**ITEM TITLE:** *Resolution PC 20 30 DR 07 Heceta Self Storage Corporation*

**RESOLUTION PC 20 30 DR 07**

**STAFF REPORT & FINDINGS OF FACT (Proposed)  
FLORENCE COMMUNITY DEVELOPMENT DEPARTMENT  
Exhibit "A"**

**Date of Report:** December 15, 2020                      **Planner:** Roxanne Johnston, CFM  
**Application:** PC 20 30 DR 07- Heceta Self-Storage Corporation, Kingwood  
**Related Files:** AR 20 10 DR 03 – Administrative Design Review & AR 19 14 VEG 07 –  
Vegetation Clearing Permit

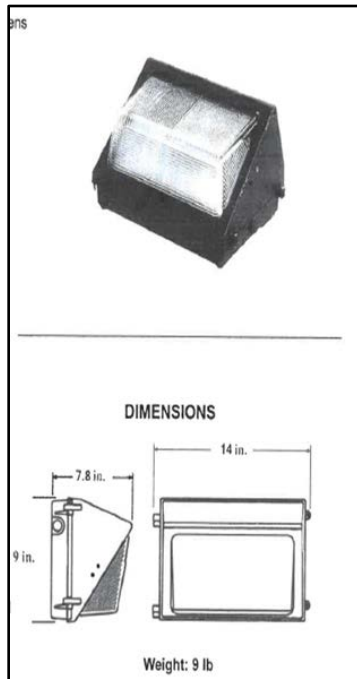
Exhibit D depicts an image of the applicant's existing 8" eave overhang on the storage facility on Highway 101. Furthermore, the same exhibit shows an image illustrating that the proposed light fixtures will be fixed at approximately 14-15 inches below the eave. An important note is that the image shows a measurement from the highest point of an eave. The main objective of the fixtures is to shine light internal to the project and into storage units across the travel lanes for visibility into the units. The applicant contends that placement of lighting inside the proposed units could lead to excessive use of electricity and could also lead to safety violations for renters that could tap into electrical components of any internal lighting (illegally) for other uses internal to the units, such as vehicle repair and other uses not allowed within the units. Lighting is proposed to be turned off upon close of each business day, save the lighting required in 10-37-4 D, below. Additionally, the applicant

argues that only a few months out of the year will require evening lighting given the fact that several months of the year will provide sufficient natural lighting into the evening hours before closing. Therefore, only a few months out of the year would require lighting which would only be needed for a few hours of the evening, according to the applicant.

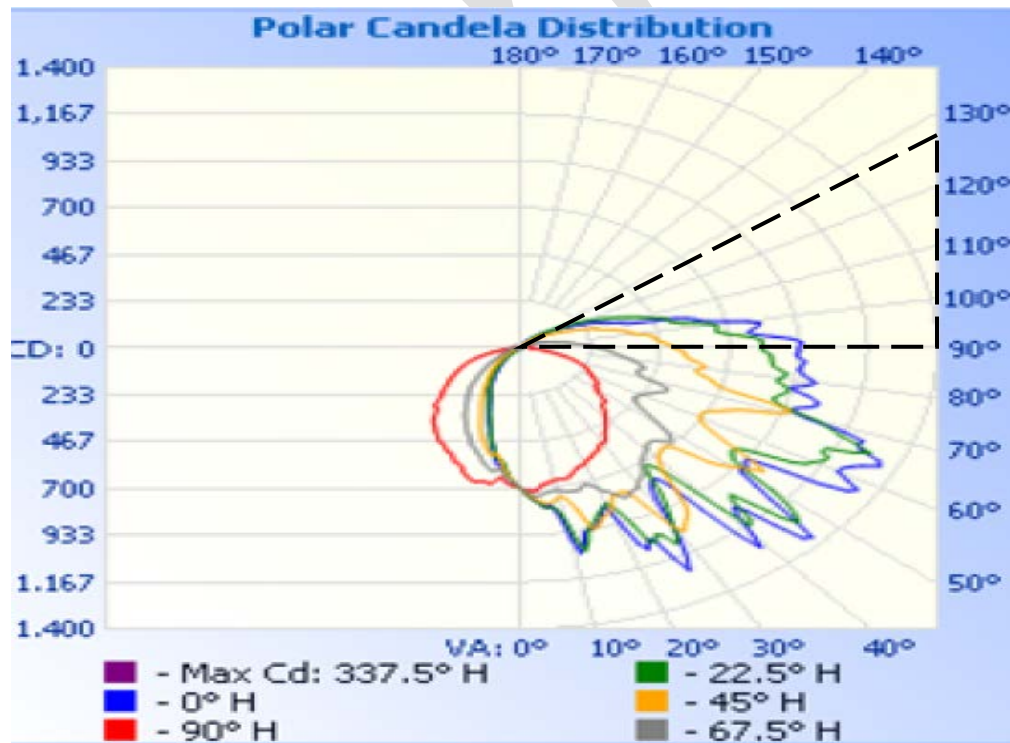
The applicant has provided a luminaire specification sheet that shows a measurement of 7.8 inches in depth, (Exhibit E, page 1 and below). As mentioned above, the eaves measure approximately 8 inches deep from the building outward. That being the case, this leaves approx. a half inch of eave covering beyond the luminaire fixed to the wall. Given this information, the eaves will not serve to play a significant role in keeping any lighting from projecting upwards. The same exhibit displays photometric data which includes a Polar Candela Distribution diagram (upper left on page 3 and also below). This diagram indicates that some of the lighting would travel over the 90-degree angle mark and upwards above the installation point, deeming it non-compliant with being full cutoff. The manufacturer categorizes the luminaire as "Outdoor non-cutoff and semi-cutoff," (Exhibit E, page 2). Engineered lighting data (Exhibit E, pages 5-8) include several rating systems for the luminaire that state that 18.7% of its light would be projected above the horizontal plane. To what extent the half-inch eaves overlap above the luminaires would have on the upward trajectory of the light is unknown. The question is whether or not Planning Commission deems the added shield of the eave and pitch of the storage unit roofs is permissible.

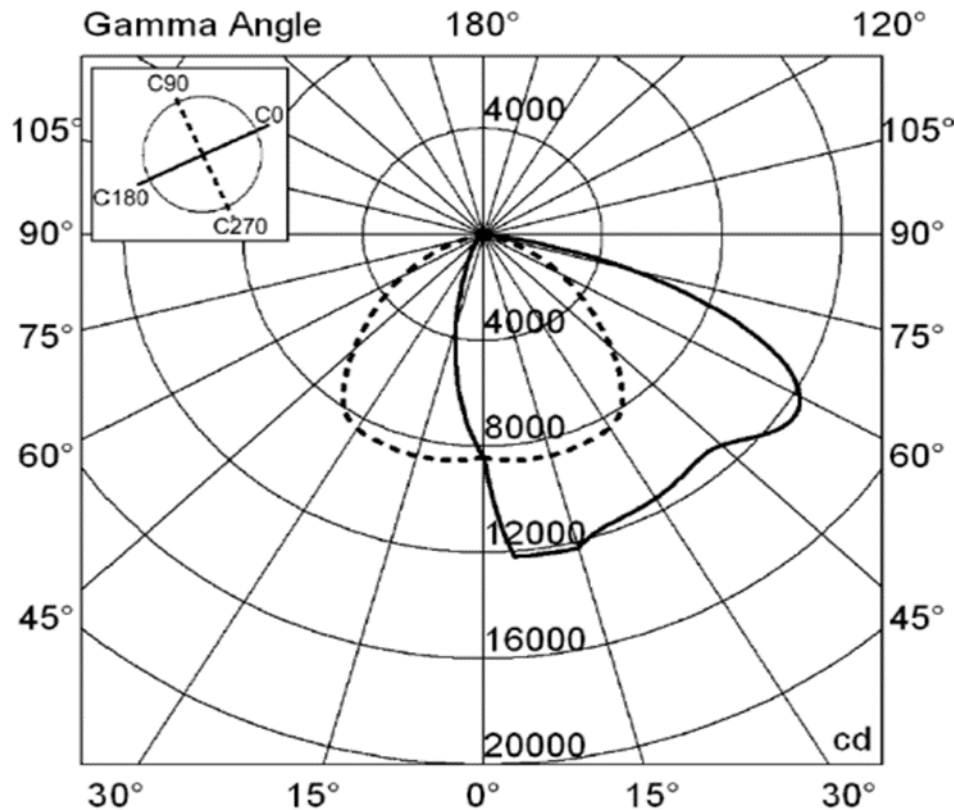
The photometric report for the proposed luminaire, below, and on page 3 of Exhibit E, is shown below. After consulting various lighting resources staff has added a dashed triangular area depicting the light traveling over the 90-degree mark; again, illustrating that lighting will be displayed above the horizontal plane and therefore not in compliance with this section on its face.

The photometric diagram below illustrates illumination throw for a full-cutoff (shielded) light in compliance with this Chapter. Lighting in this diagram does not travel over the 90-degree angle.
